NOTICE OF APPLICABILITY

**WATER QUALITY ORDER 2015-0121-DWQ
GENERAL WASTE DISCHARGE REQUIREMENTS FOR COMPOSTING OPERATIONS
WASTE MANAGEMENT OF ALAMEDA COUNTY, INC.
ALTAMONT LANDFILL AND RESOURCE RECOVERY FACILITY
COVERED AERATED STATIC PILE COMPOSTING FACILITY
ALAMEDA COUNTY**

STAFF MEMORANDUM

SUBJECT: **APPLICABILITY OF COVERAGE UNDER STATE WATER RESOURCES CONTROL BOARD WATER QUALITY ORDER 2015-0121-DWQ – ALTAMONT LANDFILL AND RESOURCE RECOVERY FACILITY COVERED AERATED STATIC PILE COMPOSTING FACILITY, ALAMEDA COUNTY**

SITE PLAN MAP
 Waste Management of Alameda County, Inc.
 Altamont Landfill and Resource Recovery Facility CASP Facility
 Alameda County

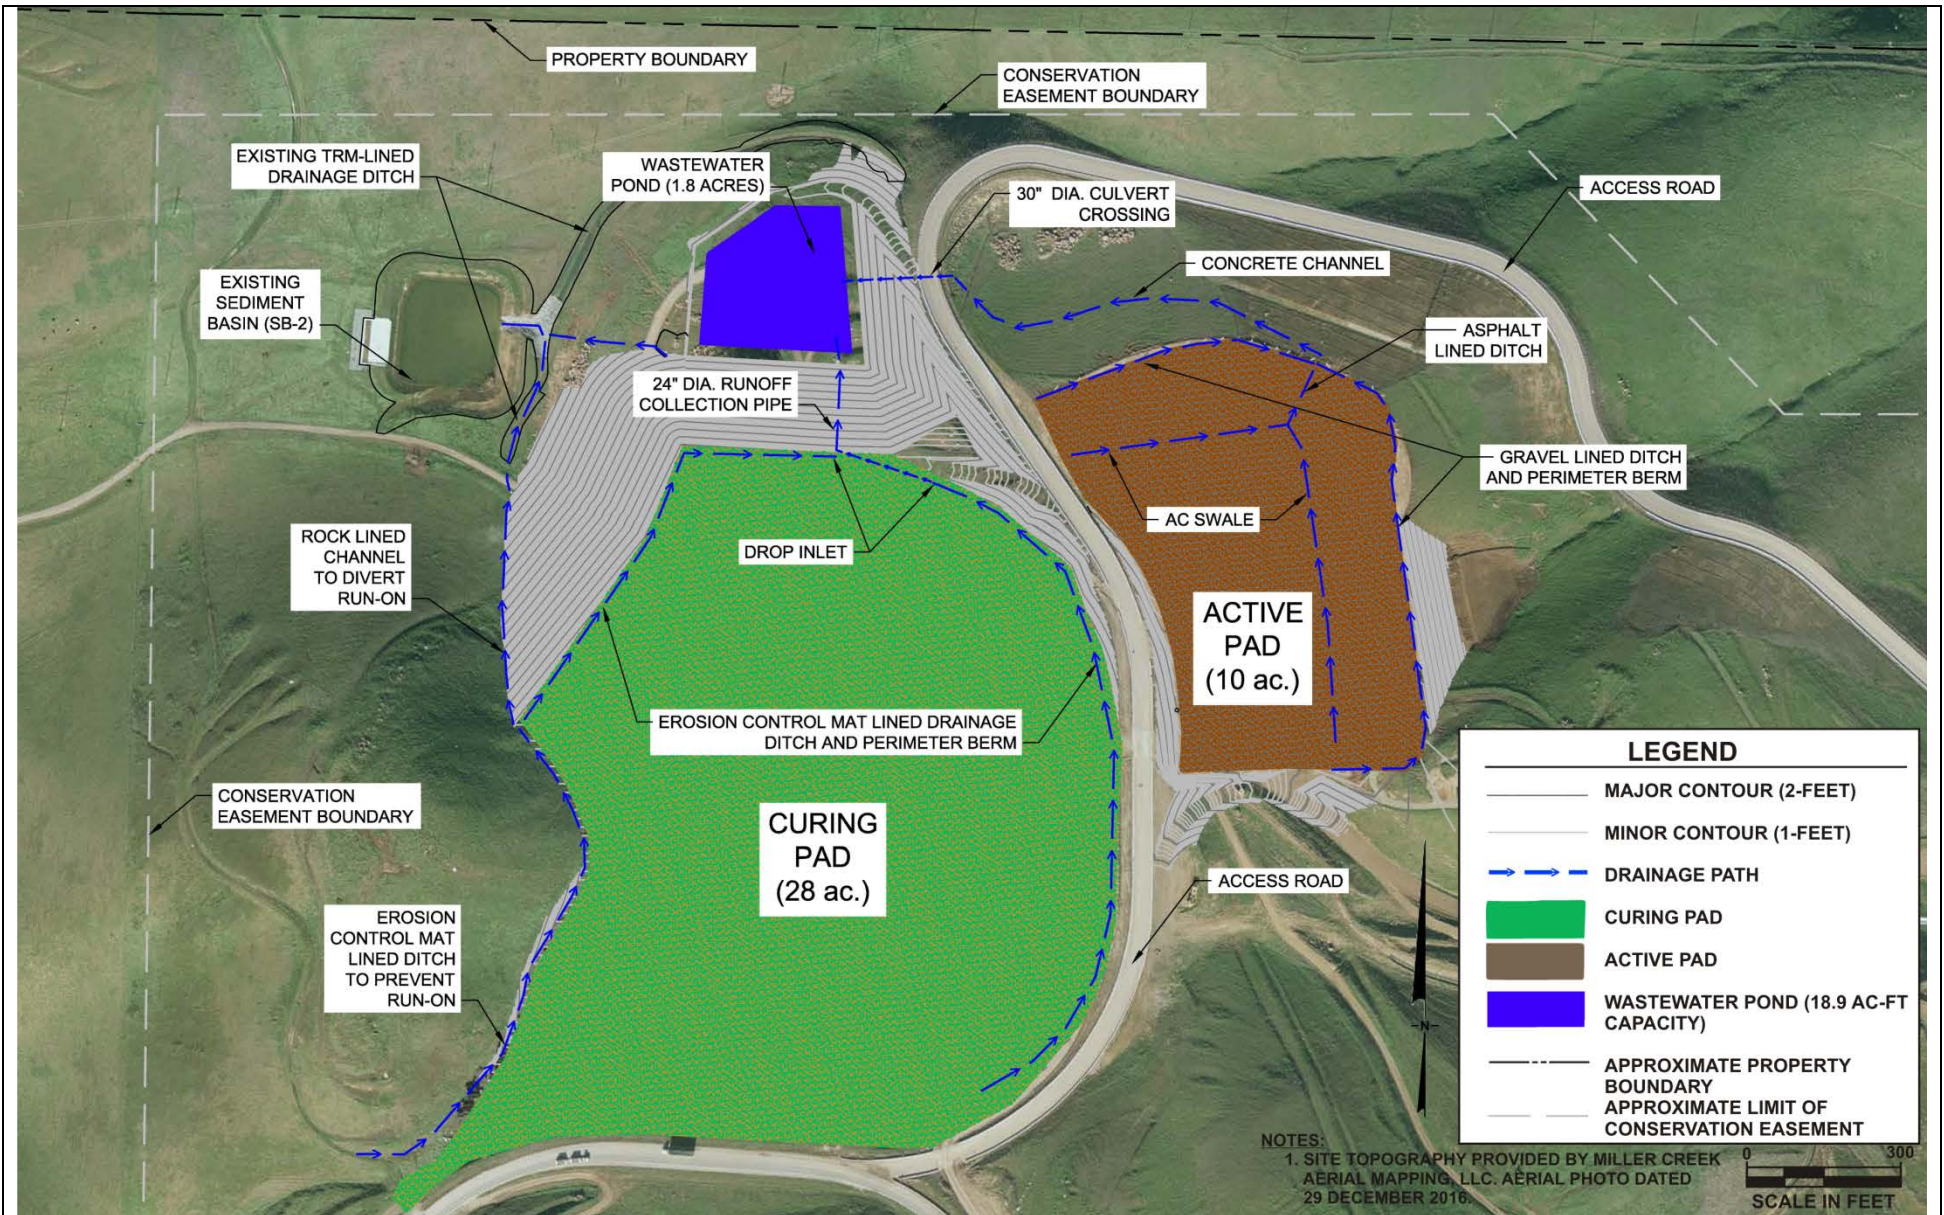
The composting operational surface will consist of a 10-acre CASP Pad and a 28-acre Curing Pad separated by an elevated access road extending north from the main landfill area south of the CASP facility, see Figure 1.

All runoff from the CASP facility’s operating surface will be collected and directed to a wastewater collection pond to be constructed immediately north of the Curing Pad area. Run-off from the CASP Active pad will be captured by a drainage ditch/berm system along the northern and eastern perimeters of the pad and routed to an overside drain plumbed to the wastewater pond via a culvert under the access road. Runoff from the Curing Pad will also be discharged to the wastewater pond via a toe-slope ditch plumbed to the pad’s central “V” drain. All drainage ditches plumbed to the wastewater pond will be sized for anticipated leachate flows plus a 25-year, 24-hour storm event and lined with compacted soil ($k \leq 1 \times 10^{-5}$ cm/s) per the General Composting Order. Additional ditches will route non-contact, sheet flow runoff from other areas (e.g., Curing Pad and access road sideslopes) to an existing sedimentation basin (SB-2) west of the wastewater pond. See Figure 1.
